Project: IEEE P802.15 Working Group for Wireless Personal Area Networks (WPANs)

Submission Title: [Resolutions to comments discussed at Taipei meeting]

Re: [In response to TG3c comments (IEEE P802.15-08-0020-05-003c)]

Comment Number #20 (5/9)

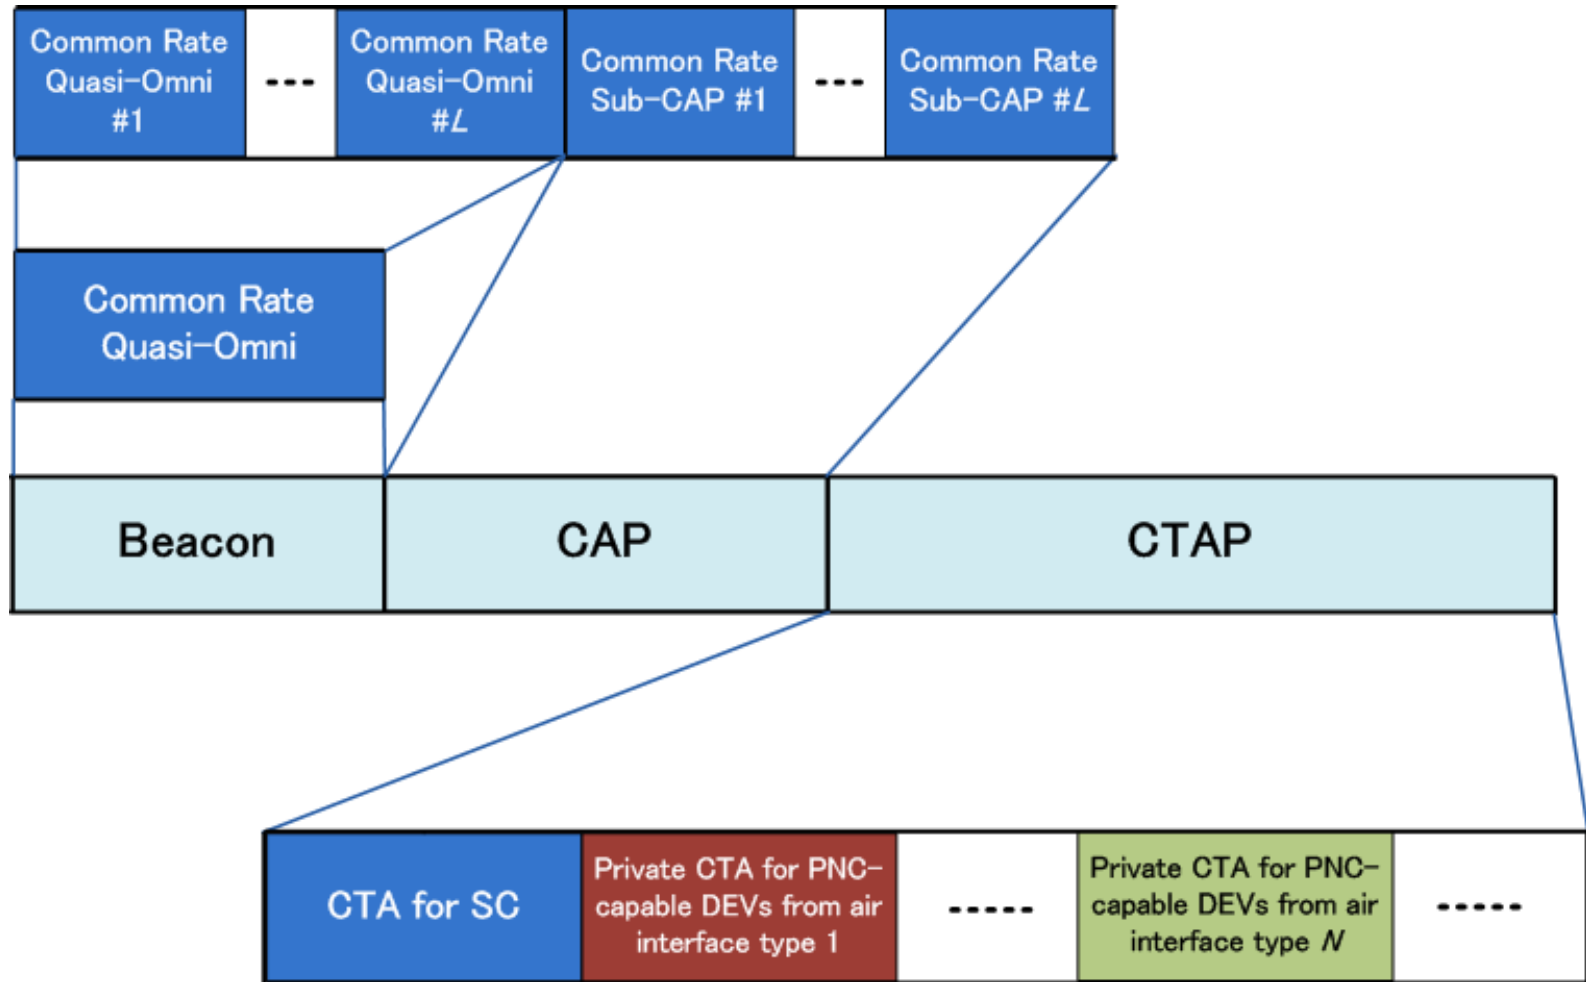
Why is MMC-PNC needed

- MMC-PNC mitigates potential interference among DEVs operating in different air interfaces
- MMC-PNC enables DEVs operating in different air interfaces to communicate with each other

Comment Number 42# (1/6)

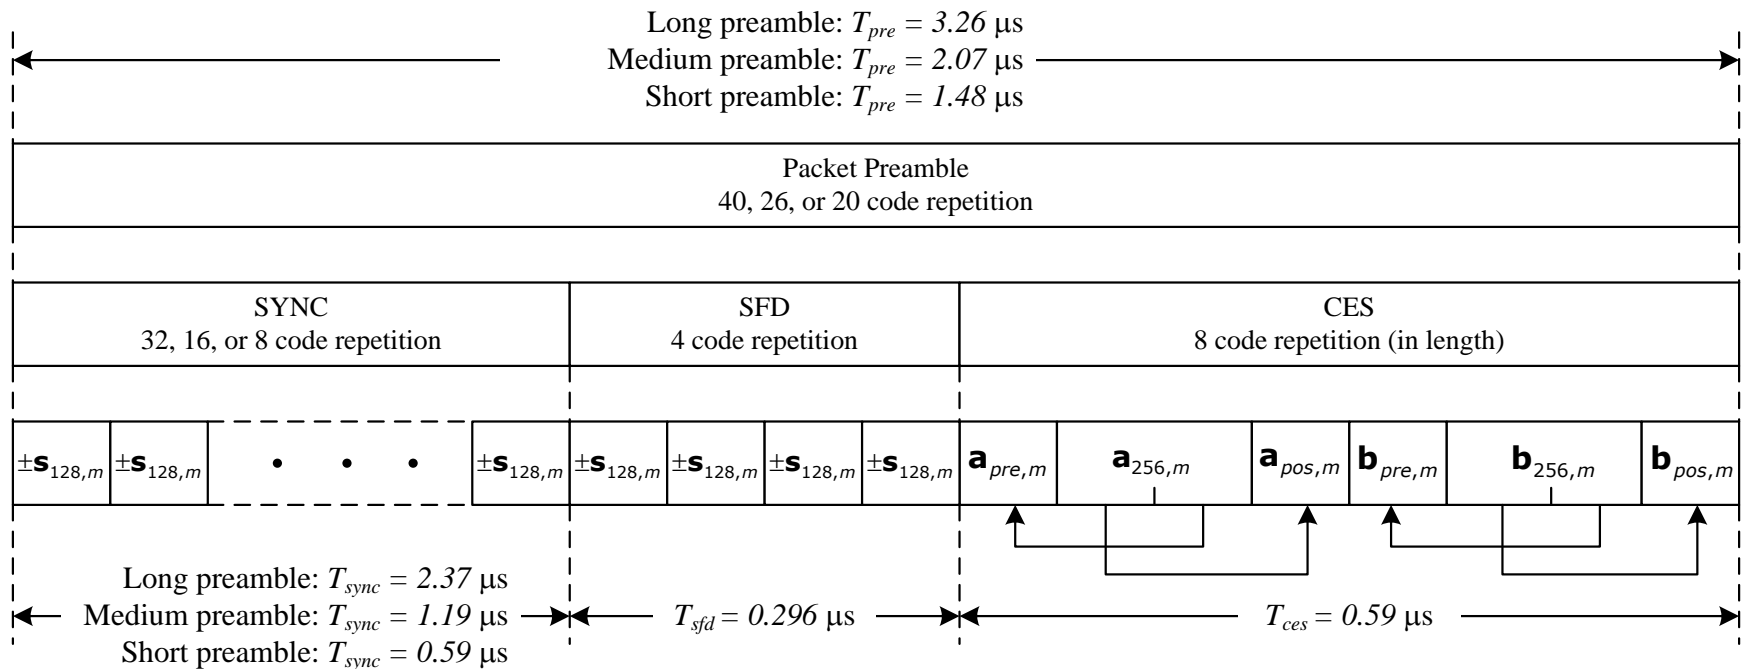
Shorter preamble: Comment 42 demanded a preamble of length around 1 us. Current shortest preamble is 1.48 us long.

Suggestions:

Removing the cover codes which generate restriction in size of SYNC .

Comment Number 42# (3/6)

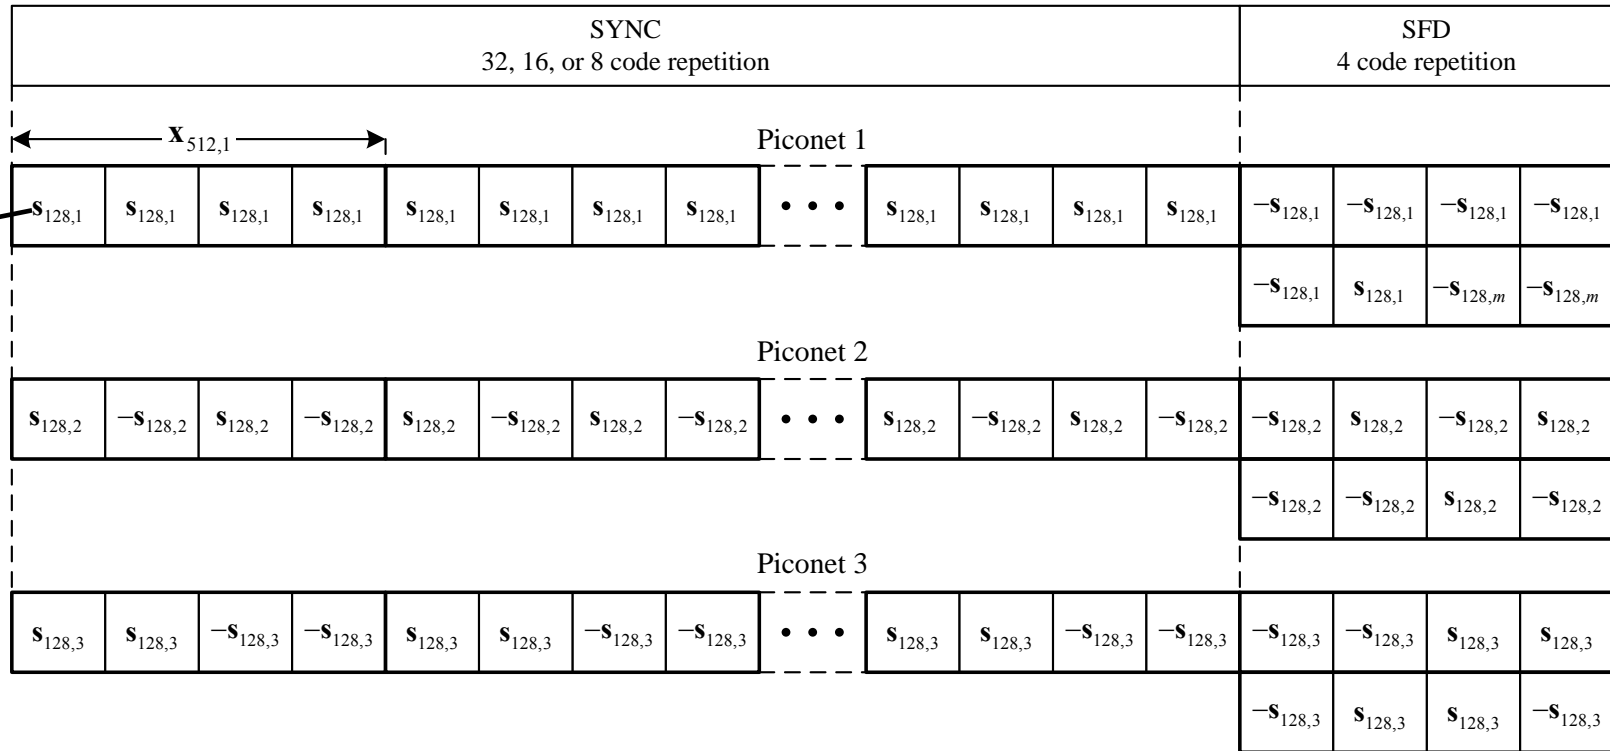
Current SYNC and SFD fields :

Comment #43

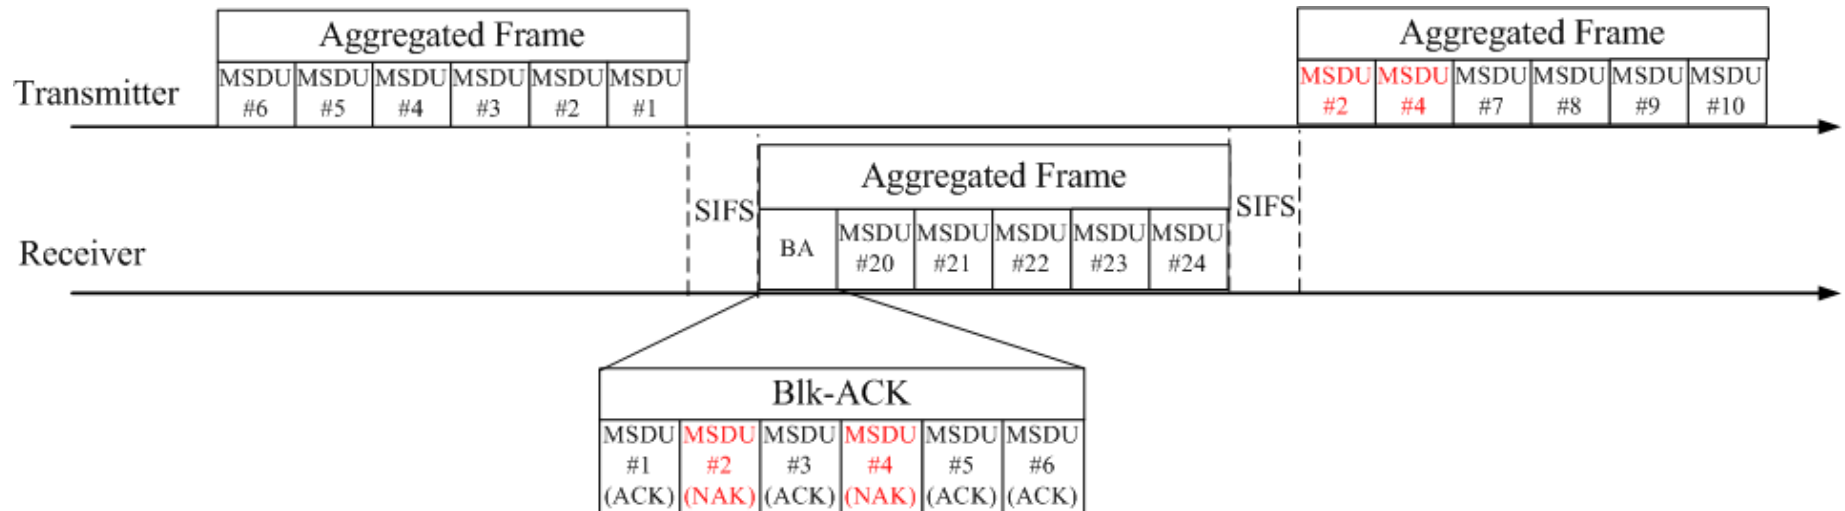
- Comment 1
 - Enable MSDU aggregation

- Response
 - Yes. One bit indication for standard mode (CoMPA's MSDU aggregation) and low latency mode (Willocity's MSDU aggregation) will be defined in base header to support both aggregation schemes

Comments #46

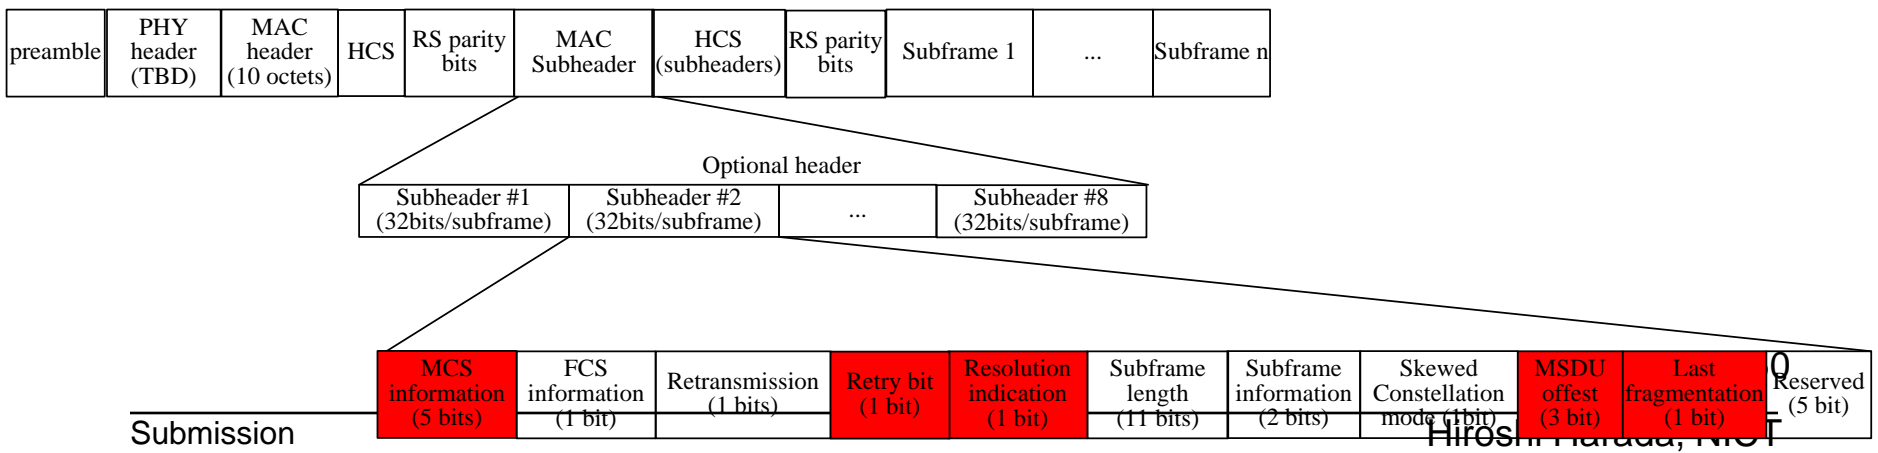
- Comment #46
 - Add new capability bit for bus_root and bus_endpoint, those devices will support low latency communication.
- Response
 - **Capability bit** for BUS ROOT and BUS ENDPOINT will be defined in **Capability IE**

Sub-header size reduction (2/2)

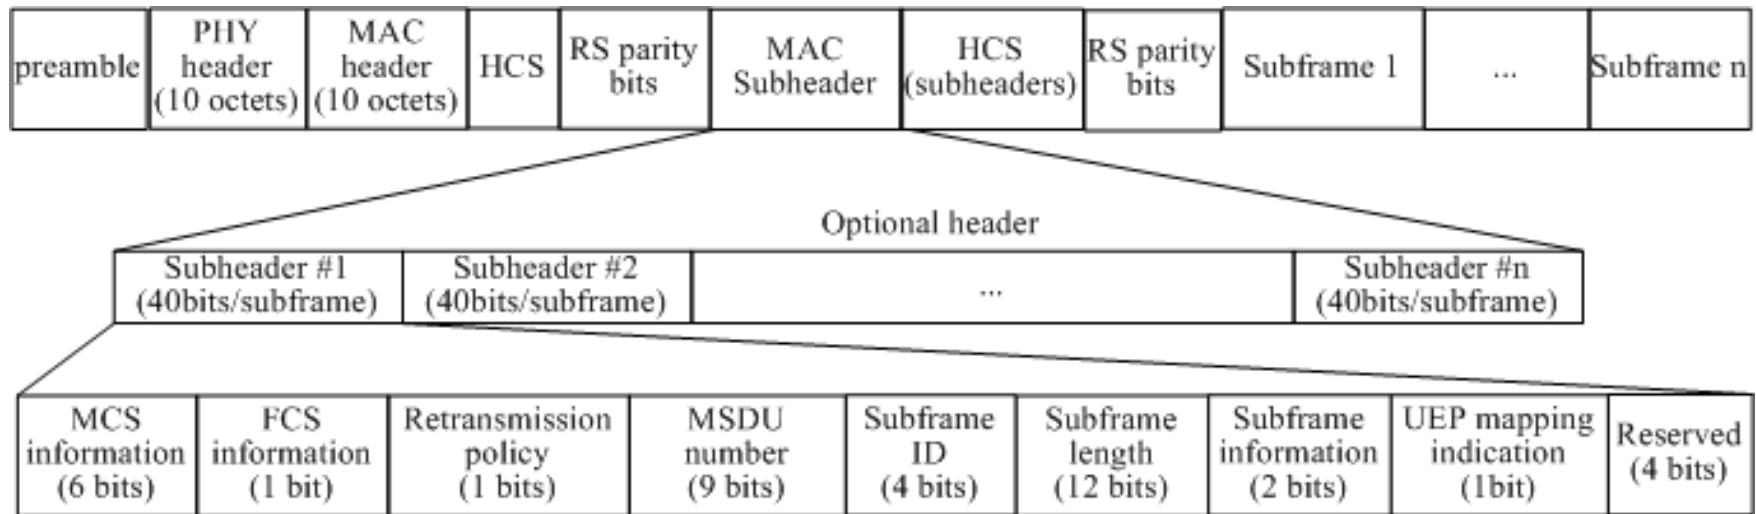
- Subheader in baseline document DF1

- Subheader size per subframe is reduced from 80 octets (40bits x 16) to 32 octets (32bits x 8)
- Subheader is changed as following
 1. Changed the number of bits for MCS information from 6bits to 5bits
 2. Removed MSDU number (9bits) and Subframe ID (3bits)
 3. Added 1bit for Retry for checking subframe duplication
 4. Added 1bit for resolution to indicate the different subframes of long subframe (1Moctets) and short subframe (40 octets)
 5. Added 3bits for MSDU offset for subframe retransmission
 6. Added 1bit for last fragmentation to support fragmentation

Comment # 11

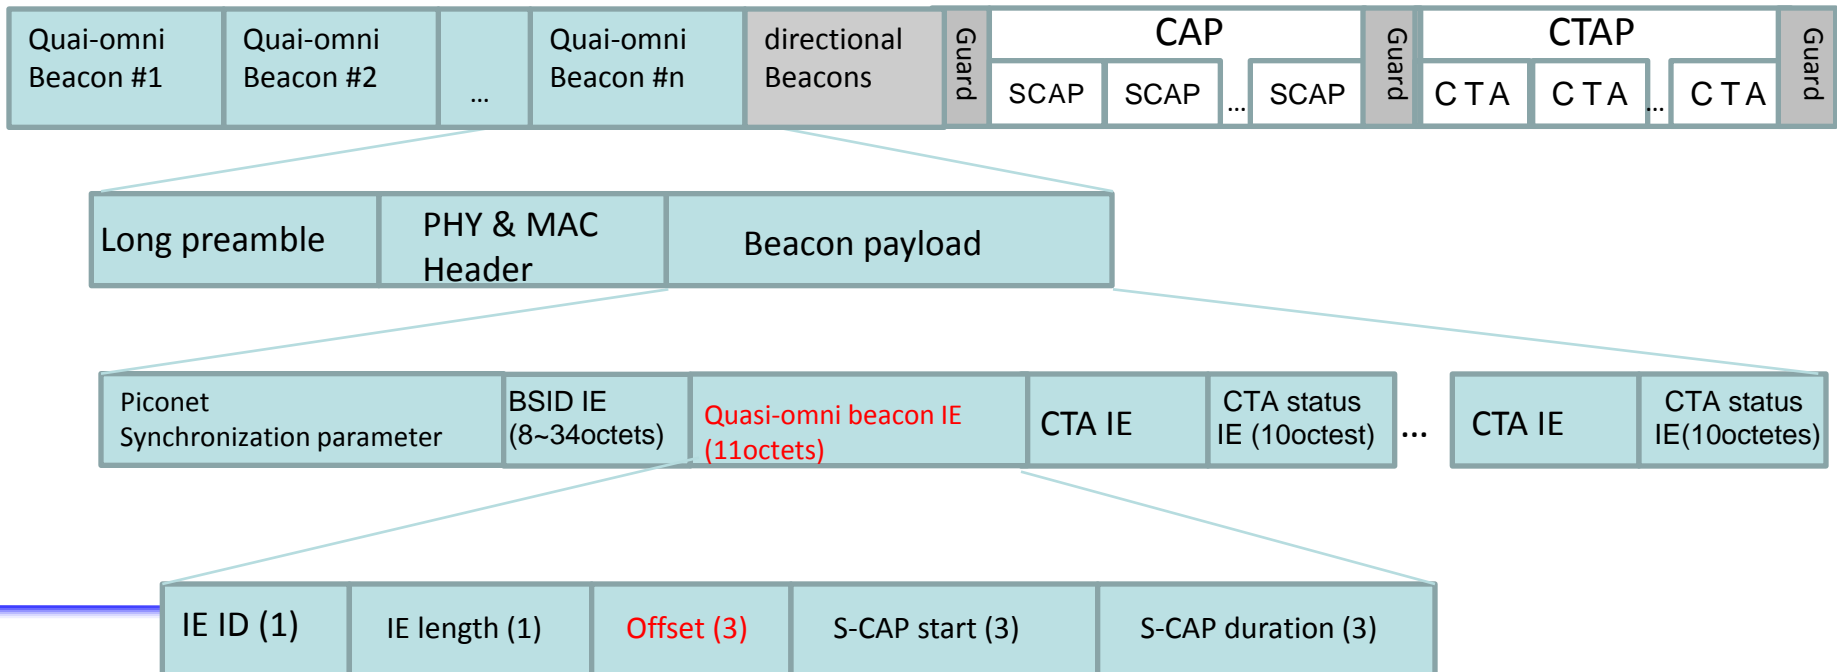
- Comment
 - How do DEVs know when the superframe starts and when the last beacon ends if they receive one beacon in the middle of a set of beacons.
- Resolution
 - Quasi-omni beacon IE is defined to indicate the offset from the start of the superframe to the first symbol of the current received beacon

Use 802.15.3 probe command for UEP information exchange

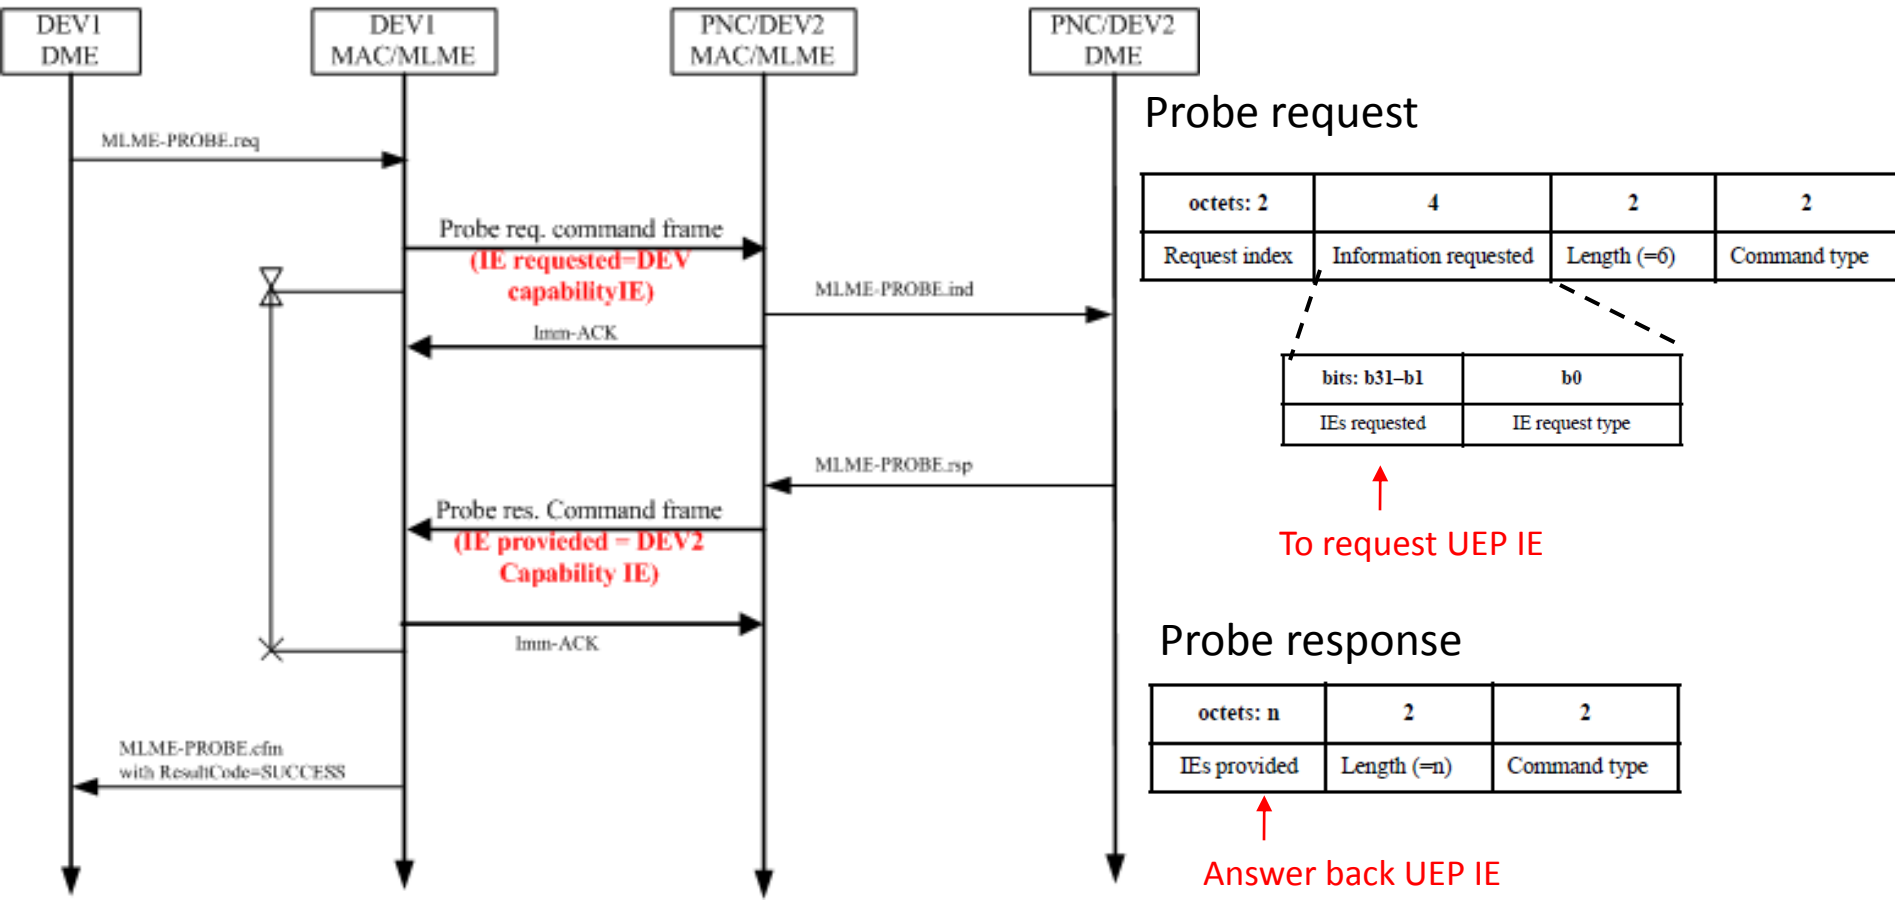
- **Comment #17**
 - Can this be done with an information element? Also, there are some updates to the frame format that need to be reviewed.
- **Resolution**
 - Yes, rather than creating new command frame, UEP (TBD) IE can be exchanged for the same purpose. This issue is related with Comment #36
- **Comment #36**
 - Rather than using commands, if the UEP capabilities are exchanged as part of the normal capabilities exchange, then the commands are not needed.
- **Resolution**
 - That is right. 802.15.3 already has the peer discovery function (use probe command) which can be used to exchange UEP information. What needed is just to exchange UEP (TBD) IE between DEVs which have intention of UEP streaming
